Packet Guide
City of Charlottesville
Board of Architectural Review
Regular Meeting
December 17, 2024, 5:30 p.m.
Hybrid Meeting (In-person at Council Chamber and virtual via Zoom)

BAR #24-12-02

BAR # 24-10-02

Project: Three-story apartment building

REVISIONS BASED ON BOARD'S COMMENTS:

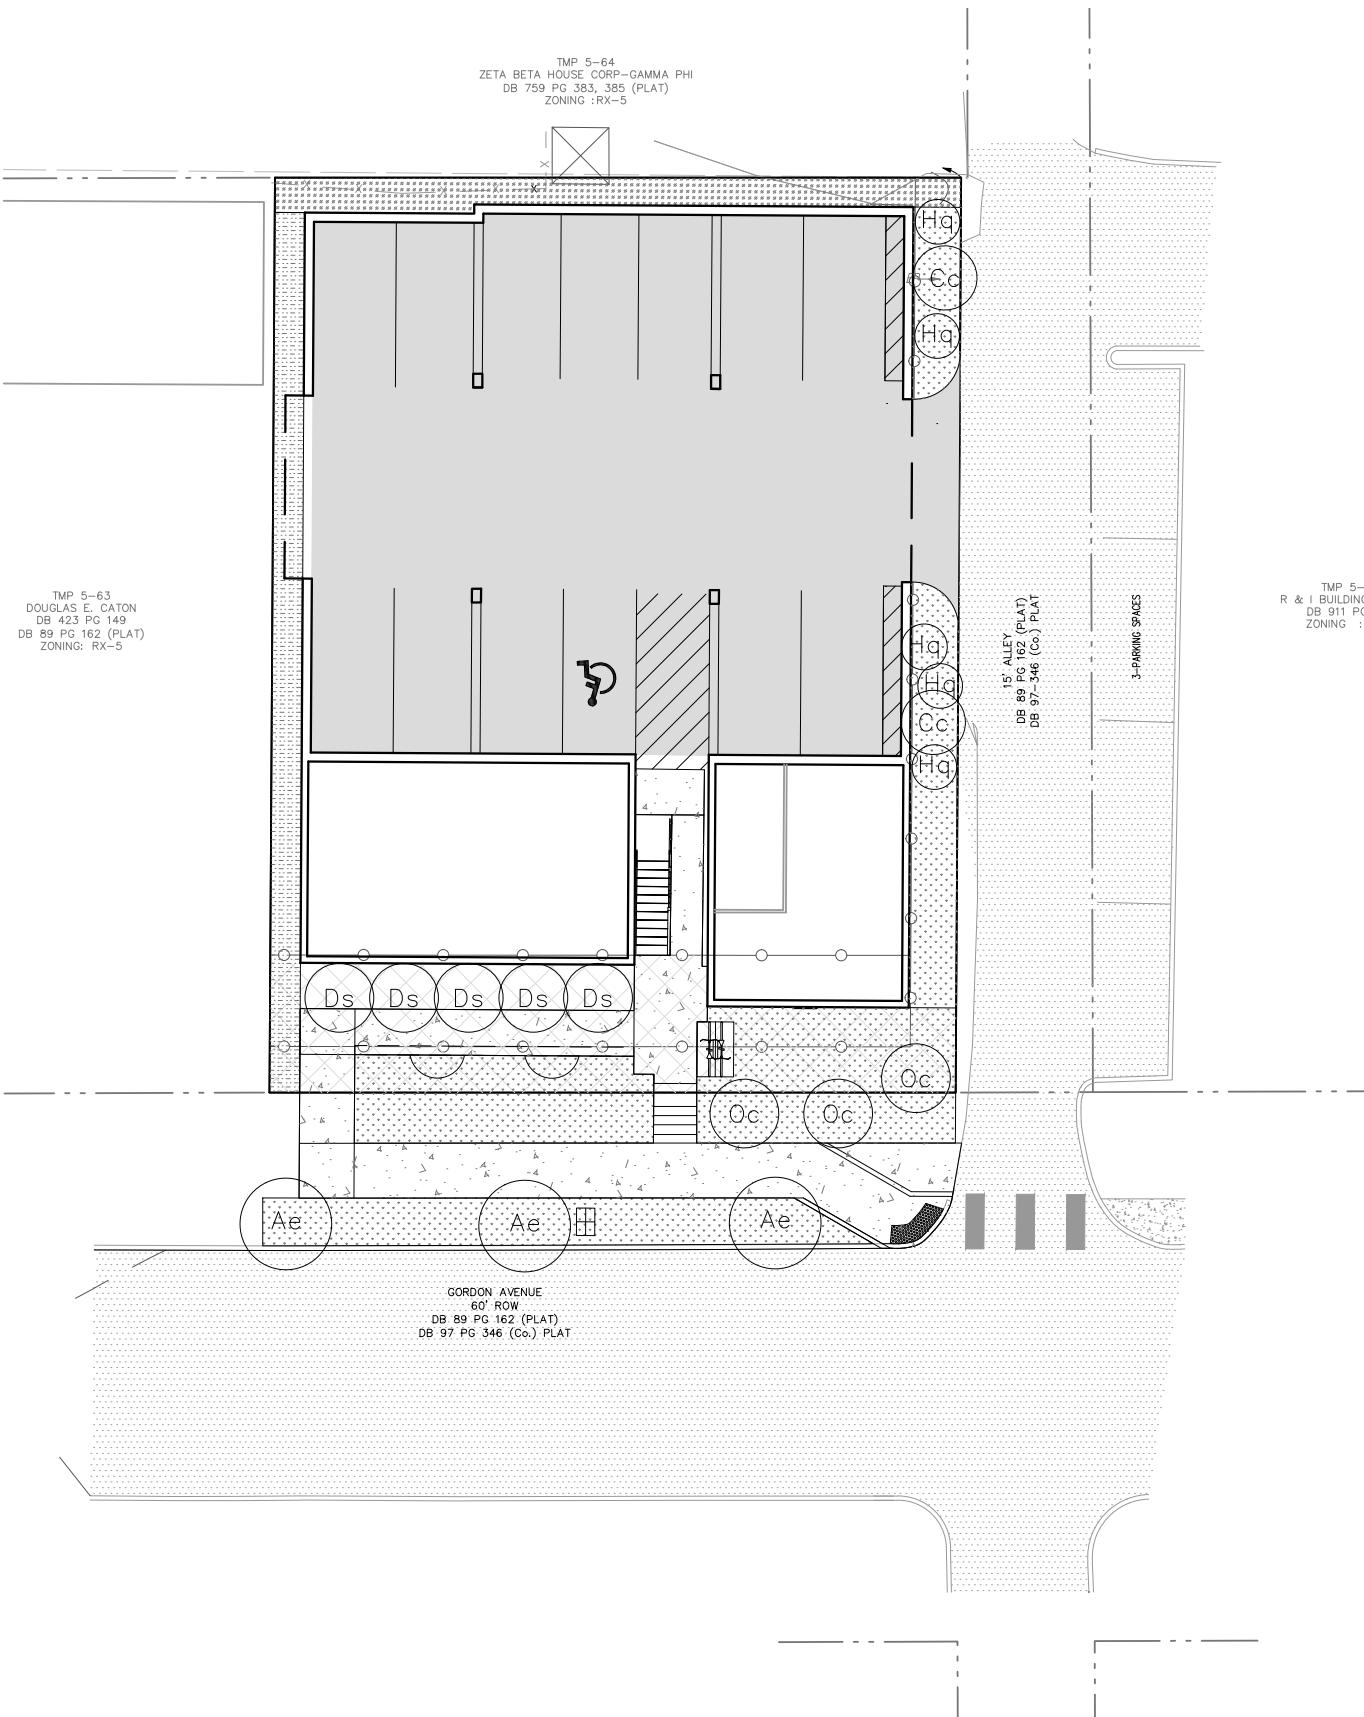
Request CoA for construction of a three-story apartment building with internal parking. Specifically note items 7, 8, and 9 summarized on sheet 14 of the submittal.* See a side-by-side comparisons in the attached. (* Items 1 through 6 were modifications shown in the October submittal.)

- 1. RESIDENTIAL STANDING SEAM METAL ROOF DETAIL**
TO REPLACE COMMERCIAL STANDING SEAM METAL ROOF RIDGE CAP.
- 2. EIFS SYSTEM** TO REPLACE HARDIE PANELS TO PROVIDE A MORE SEAMLESS LOOK AND TO EMPHASIZE WINDOW ORGANIZATION THROUGH A RATIONAL ORGANIZATION OF JOINTS.
- 3. ELIMINATE VISUAL ODITY OF “FLOATING” BRICK**
OVER LARGE SCALE OPENINGS BY REPLACING IT WITH HARDIE SIDING.
- 4. SCREENING AND PLANTING ADDED AT GARAGE** TO FURTHER REDUCE THE IMPACT OF TUCK-UNDER PARKING.
- 5. FURTHER DEVELOPMENT OF LANDSCAPING, PEDESTRIAN ACCESS, AND AMENITY SPACE.**
- 6. EMPHASIZE THE GABLE FORM AND ADDRESS THE STREET WITH CANTILEVERED VOLUME.**
- 7. NEW ENTRY ELEMENT AND DOORWAY** INTO A COMMON LOBBY SPACE.
- 8. STAIRWAY AND BALCONIES** FACING GORDON PUSHED BACK TO BE LESS VISIBLE.
- 9. NEW SCREENING ON ROOF** TO HIDE ROOF TOP UNITS.

SOUTH ELEVATION

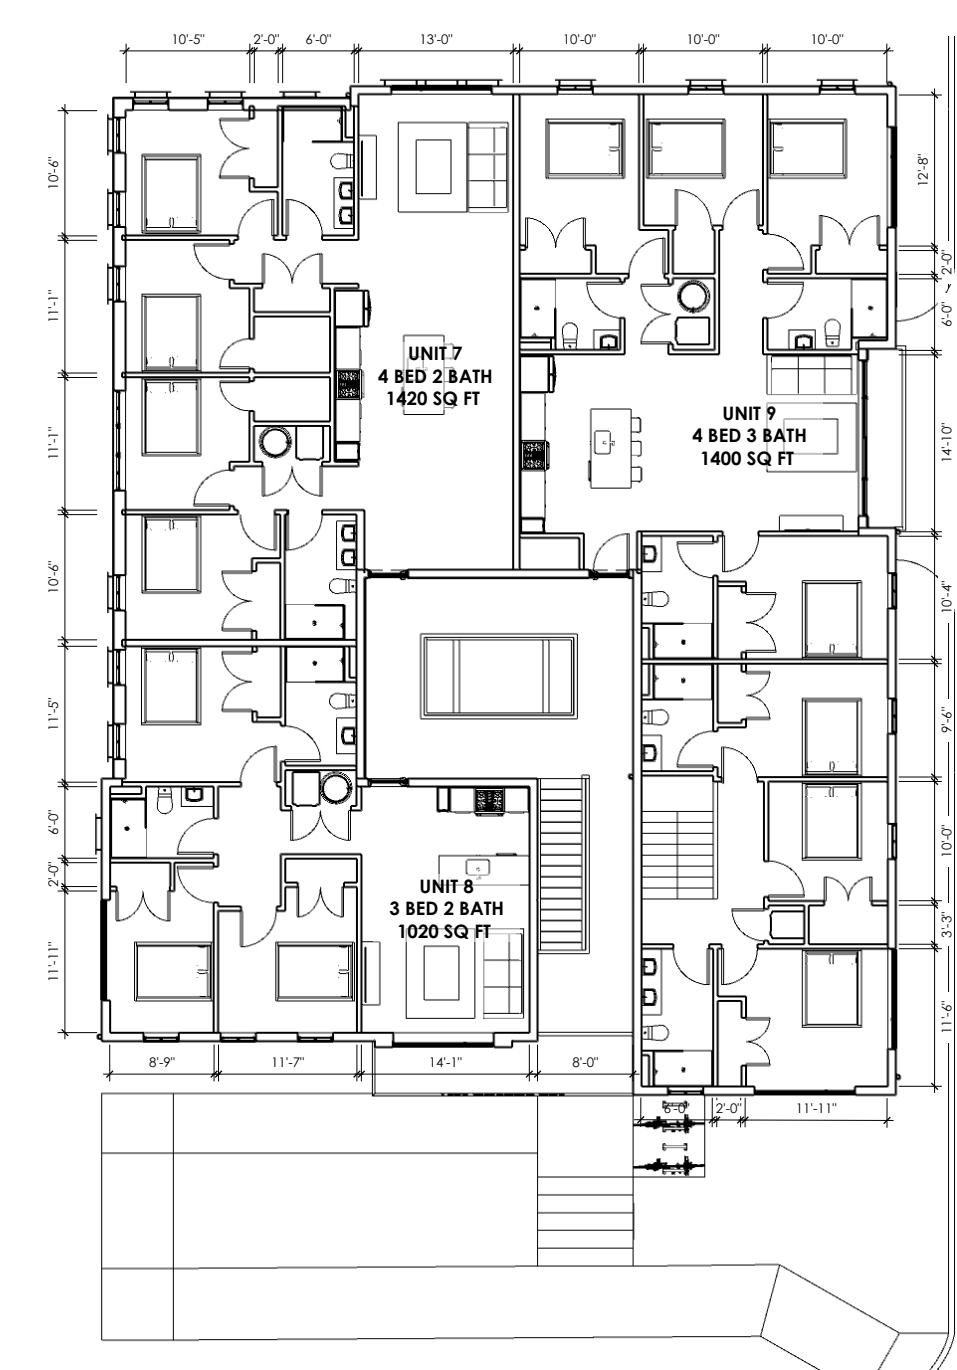
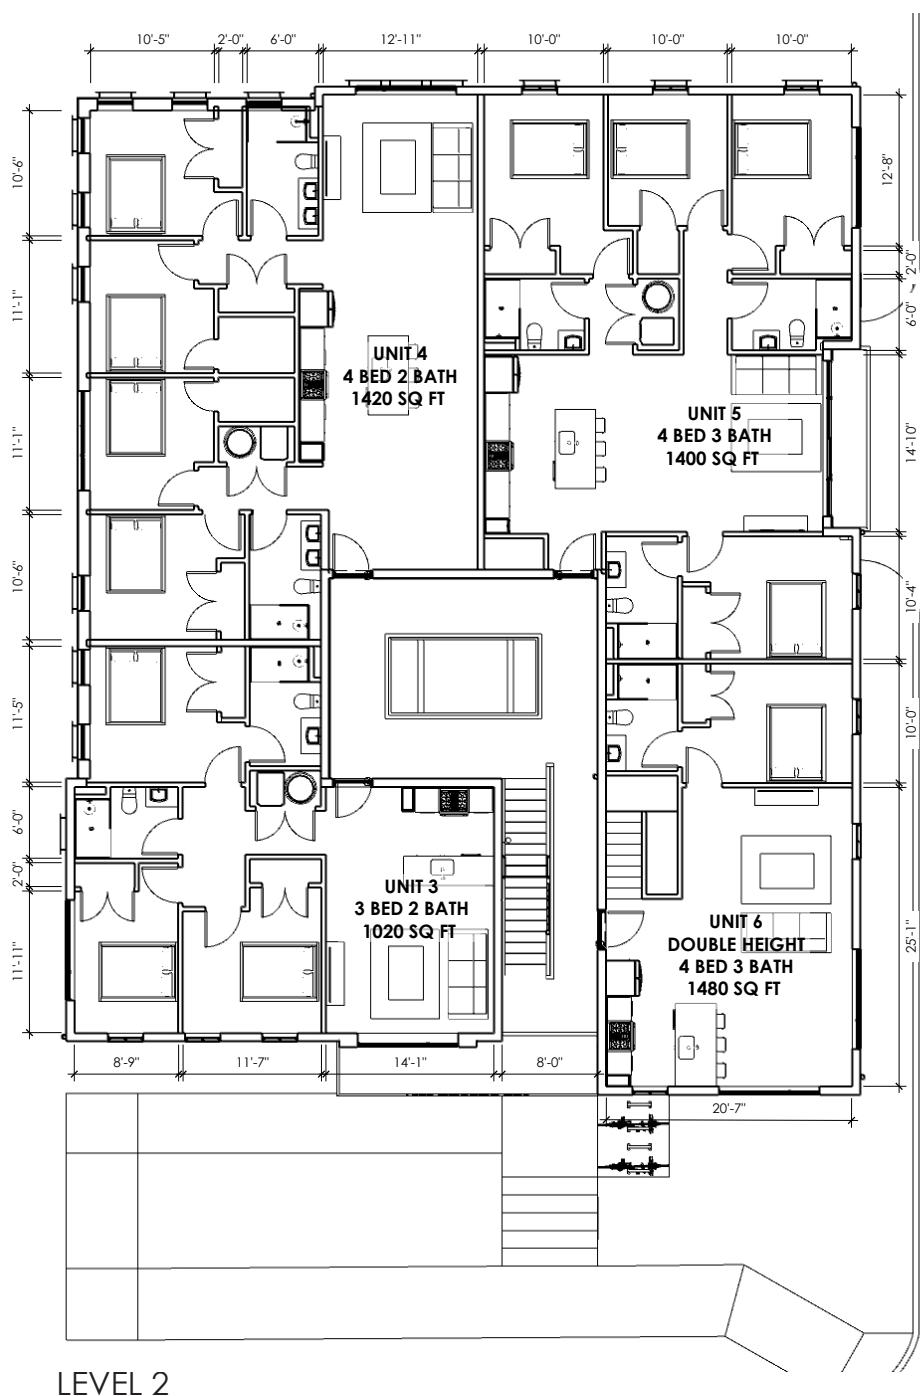
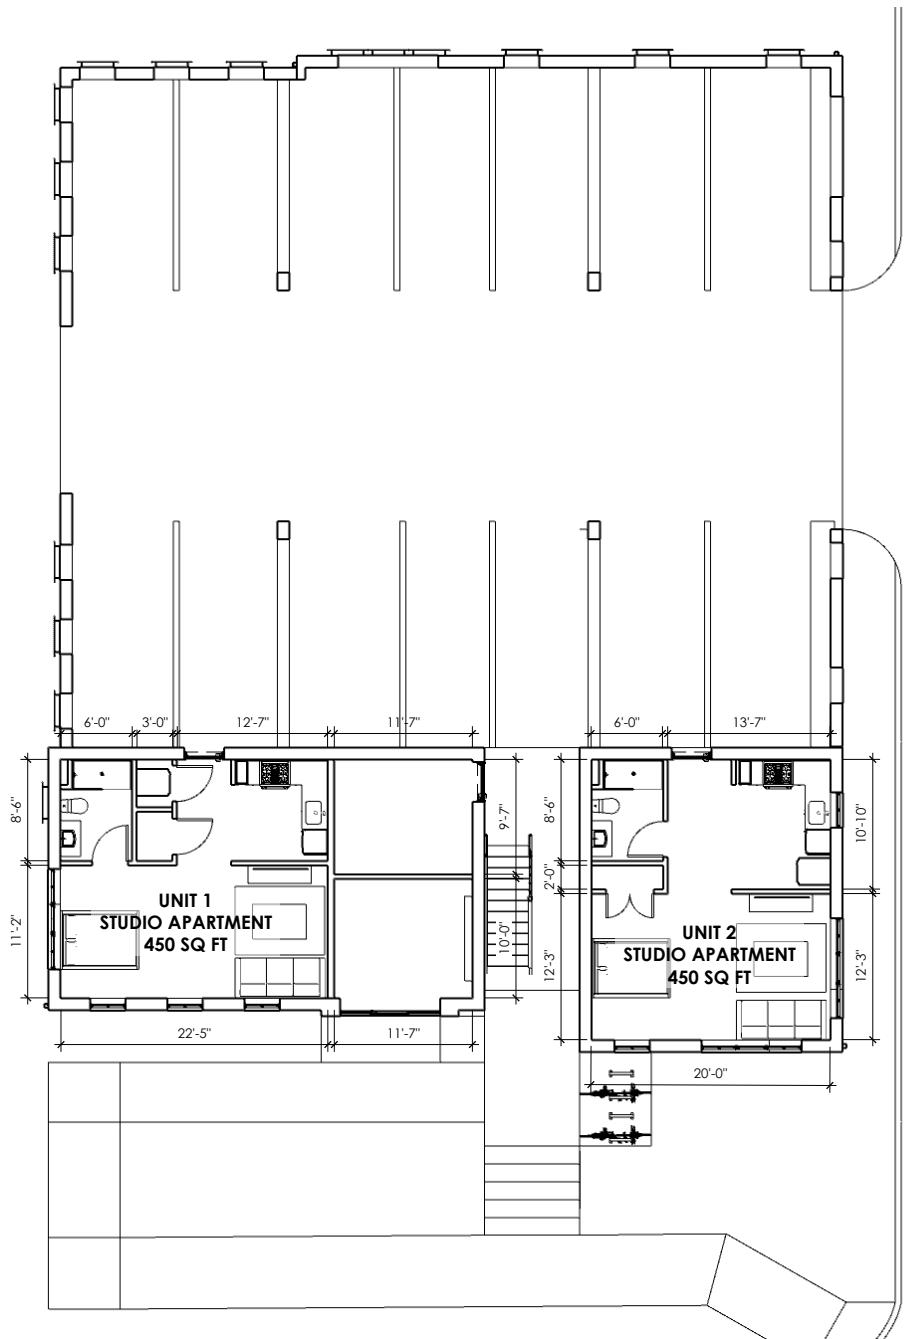
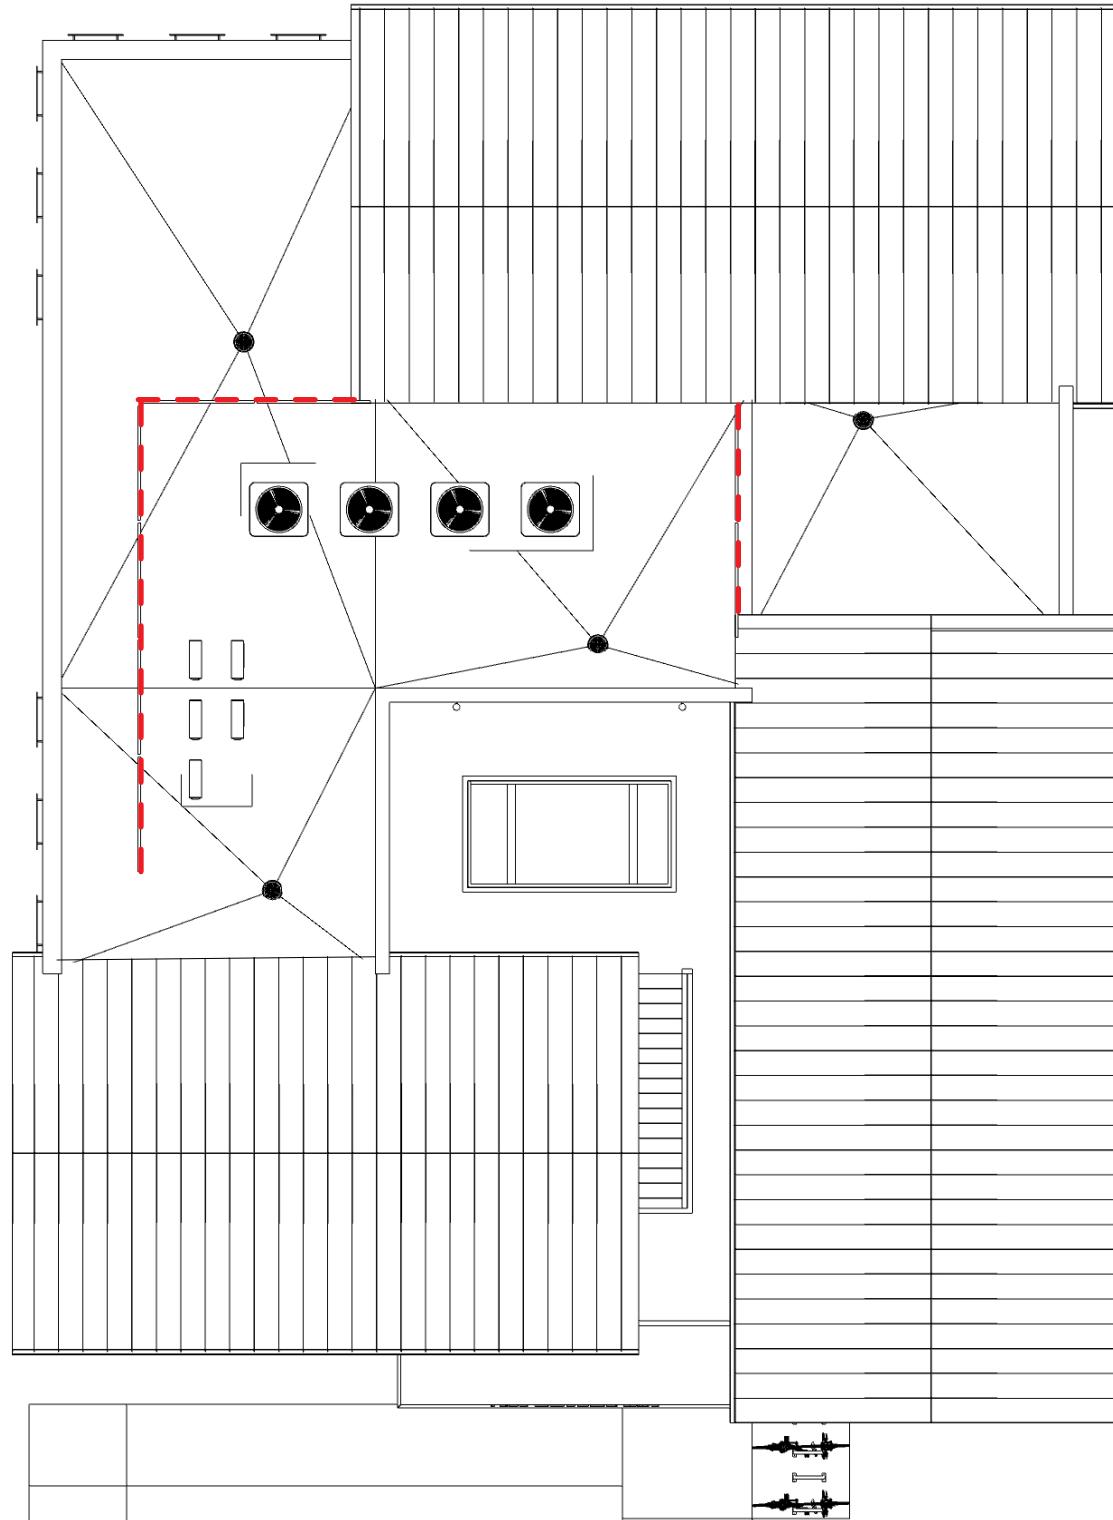
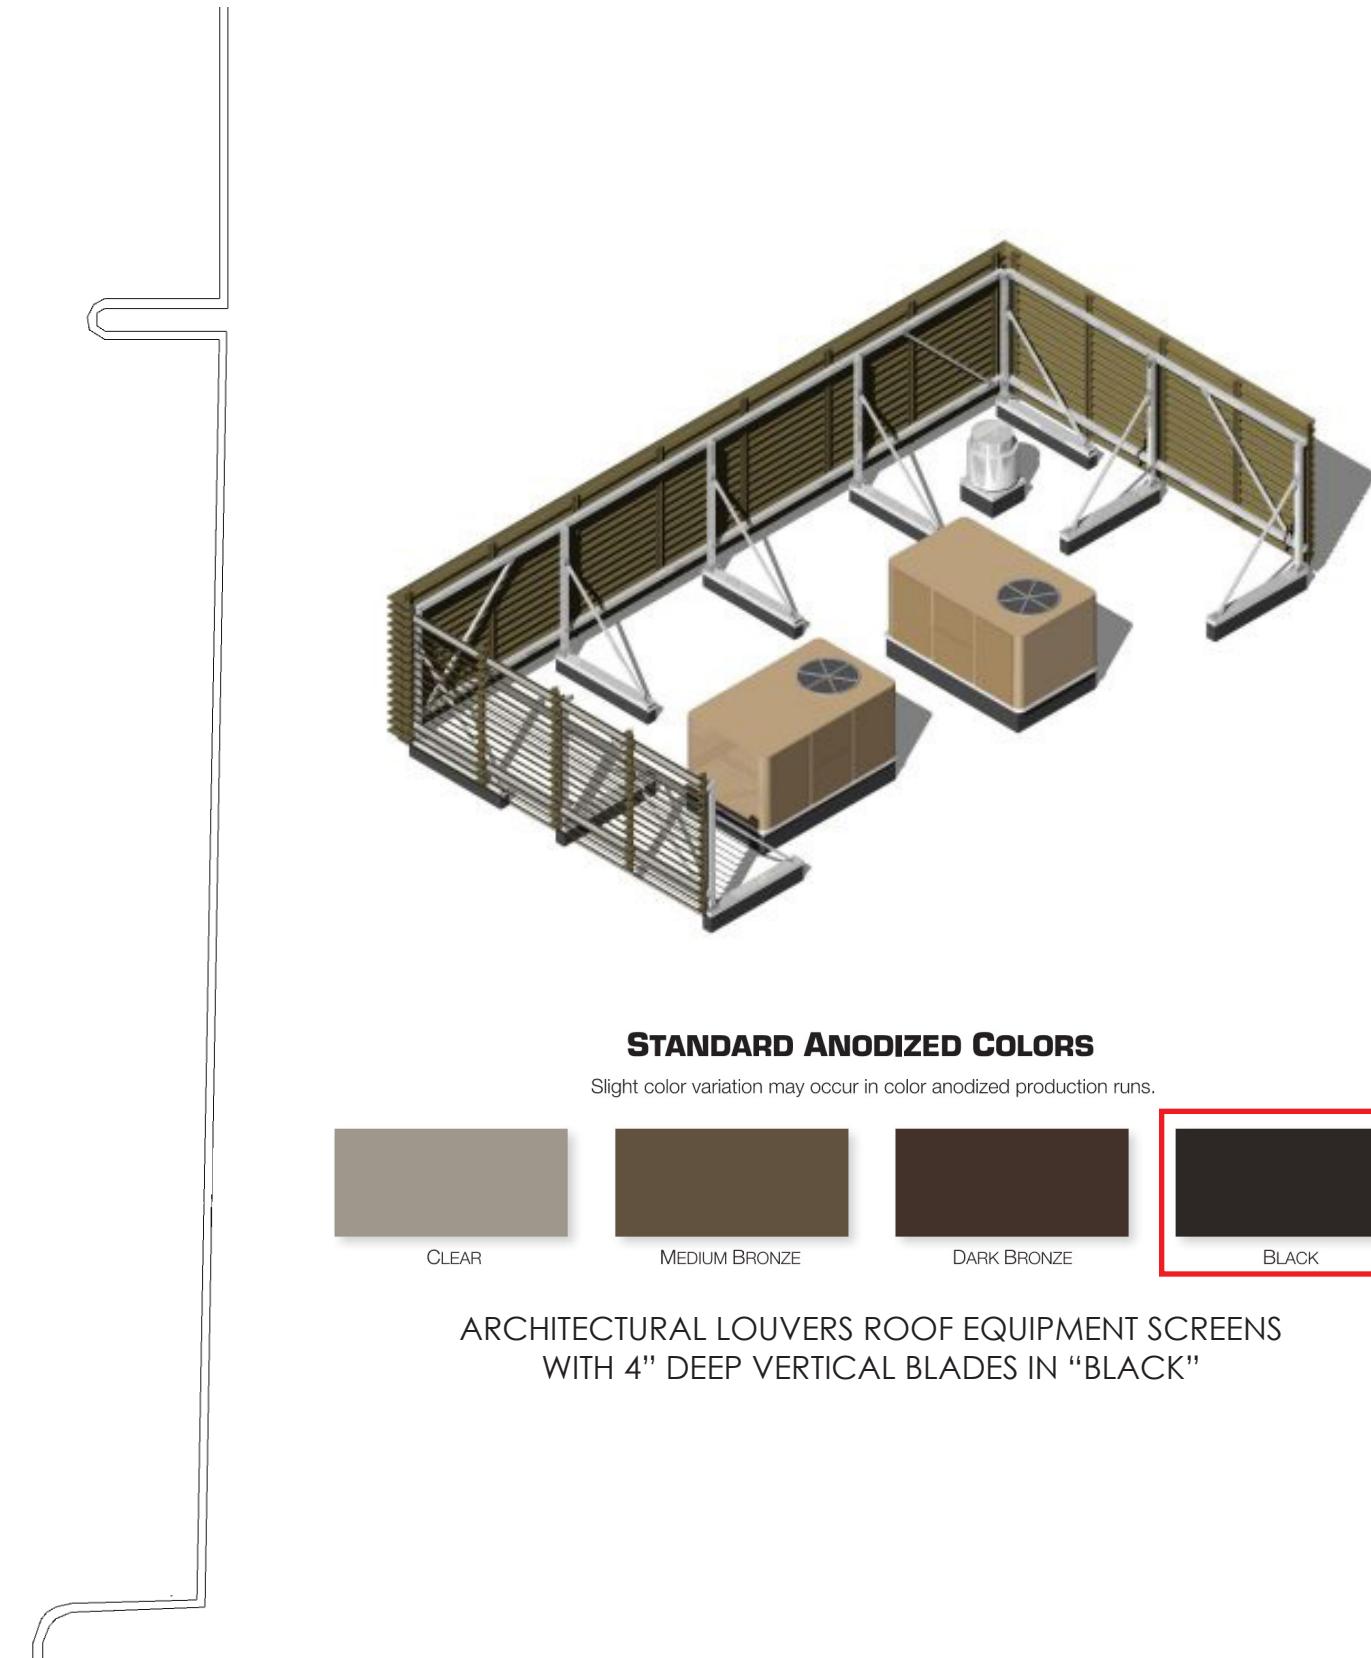
I appreciate the screening on the garages. It says Virginia Creeper Ivy. I assume that means Virginia Creeper or Ivy. Virginia Creeper will lose its leaves in the winter. Ivy will stick to the brick and eat the EIFS. I don't know if there is something else you can find for that. I don't know if that was a placeholder. You probably should not put any plant material that is going to stick to the EIFS. Are the eave materials fiber cement trim? It does look like metal turning over the eaves. Is it supposed to be fiber turn detail? The front façade is still monolithic. You are going for a contemporary look. With that monolithic and plane look to it, it is lacking as far as context for the residential portion of the neighborhood.

Mr. Timmerman – I would like it if you came back with the brick you are proposing. If it is an EIFS, the color sample would be the best. It is hard to tell on renderings sometimes what the color is meant to be. There is sunlight and reflection that sometimes distorts that. Having physical samples of the 2 main bricks, if not the tertiary materials and product information on the screens, would be great. Not all those decorative screens are the same. It is hard for me to tell where the windows are in line with the EIFS, how far back they are. That might be a simple window detail to understand the thickness, the materials return would help.

Mr. Birle – I am wondering if we would not help to deemphasize the balconies on the 2nd and 3rd floors and put more importance to the pedestrian level entrance and create more of a traditional porch. I like the idea of having a space between the 2 forms. It scales that back down to the neighborhood. Those overhanging balconies give it an apartment feeling in a not positive way. The door could be incorporated. If there is more emphasis on the ground plane rather than the 2nd and 3rd floor, the doors might be part of that.

Mr. Schafer – Nobody is touching eaves in this location. It is on the 2nd story. It is not at the pedestrian level. It is on a gable end. It happens to be prominent in terms of building form. I understand the color comment in our renderings. We can address that color comment. I would encourage you to drive down Virginia Avenue and look at that project. With the guidance from the BAR, there are big, large areas of eaves that have tight control joints that align with windows. There is rationality and order behind those things. It works. Isn't the Church across the street stucco? There is quite a bit of stucco on this street contextually. I don't think it is out of place from a material perspective. It is maybe a color issue. From my perspective, it is a lot more thoughtful and controllable than working within hardy panel. We are going to take a 4-by-8 hard panel sheet as hard as we can try to align things, you will see more trimlines, joint lines, and aluminum trim that does not line up. I am not opposed to looking at other materials. I felt the direction we were given last time was good. We utilize that staircase to break down the building form into residential massing. That is differential to our context. How can we take this building footprint that is adjacent to us and not overpower it with a building form that could be 2 more stories taller and even wider than we are showing to some degree. There is a shadow line and big void. That creates a breakdown in the building mass, which I think is a positive. I do like the comment. We will continue to study it.
